Access Compliance Report

Public Rights-of-Way

Intersection ID: 13871	Main Street: E_5TH_ST	Cross Street: HAWTHORNE_LN	Location: S
ADA ID: BB4E6C0171D0	Ramp Type: PerpDiag	Initial Pass/Fail: Pass	Overall Compliance: No
			Severity Score: 10.25

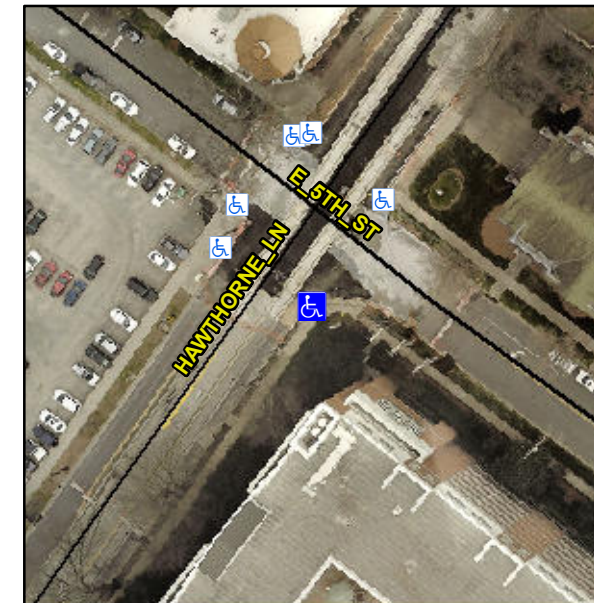
Not Found, R304.5.3, R304.2.1, R304.2.2-Perp, R304.3.2-Para, R305.2

Compliance	Description	Data	Compliance	Description	Data
N/A	Ramp Length (in)	60.0	Yes	Ramp Slope (%)	5.1
Yes	Ramp Width (in)	96.0	No	Ramp XSlope (%)	4.5
N/A	Flare Type LT	Sloped	N/A	Flare Type RT	N/A
N/A	Flare Slope LT (%)	5.5	Yes	Flare Slope RT (%)	5.8
N/A	Flare Traversable LT?	Yes	N/A	Flare Traversable RT?	Yes
No	Landing Length (in)	N/A	Yes	DWS Provided?	Yes
No	Landing Width (in)	N/A	Yes	DWS Contrast?	Yes
No	Landing Slope (%)	N/A	Yes	DWS Length (in)	24.5
No	Landing X Slope (%)	N/A	Yes	DWS Full Width?	Yes
N/A	Landing Curb? (Y/N)	No	No	DWS Offset (in)	3.5
N/A	Shared Landing?	N/A			
Yes	Gutter Ponding?	No	Yes	Gutter Slope (%)	3.1
Yes	Gutter Lip Ht (in)	0.0	Yes	Gutter X Slope (%)	0.0
N/A	Painted X Walk1?	Yes	N/A	Painted X Walk2?	Yes
	X Walk 1 Direction	To NE		X Walk 2 Direction	To NW
N/A	X Walk 1 Width (in)	122.0	N/A	X Walk 2 Width (in)	114.0
	X Walk 1 Slope (%)	3.5		X Walk 2 Slope (%)	1.3
	X Walk 1 X Slope (%)	1.1		X Walk 2 X Slope (%)	3.6

Remove & Replace Curb Ramp With Two New Directional Ramps or Equivalent.
